STATE OF WASHINGTON  
DEPARTMENT OF ECOLOGY

20-NWP-147

Re: Dangerous Waste Compliance Inspection on April 20, 2020, at the Double Shell Tank System and 204-AR Waste Unloading Station, RCRA Site ID: WA7890008967, Nuclear Waste Program (NWP) Compliance Index No.: 20.699

**Washington Department of Ecology  
Nuclear Waste Program  
Compliance Report**

**Figure 1 Issue Found Under Riser #54 in 241-AW-102**

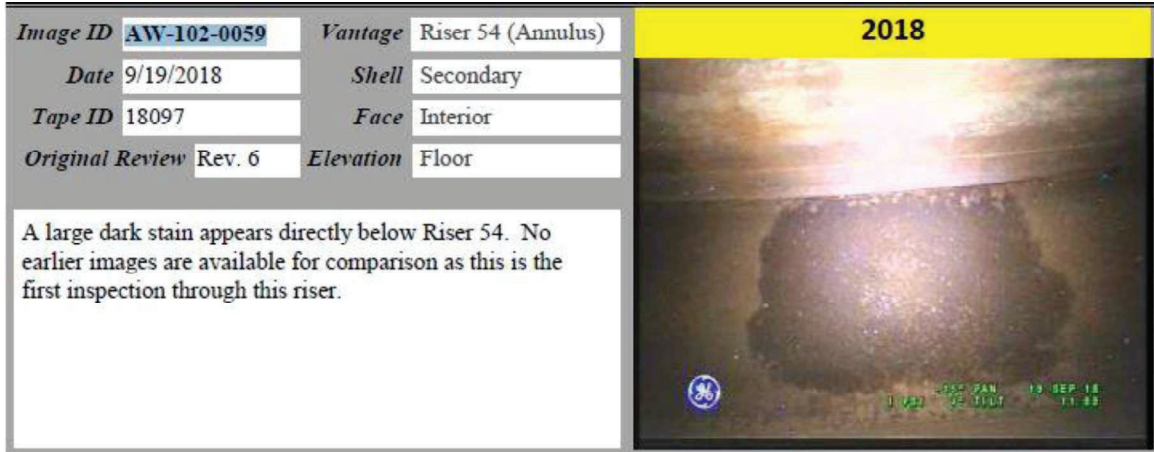
See photo below of issue found under Riser #54 in 241-AW-102:
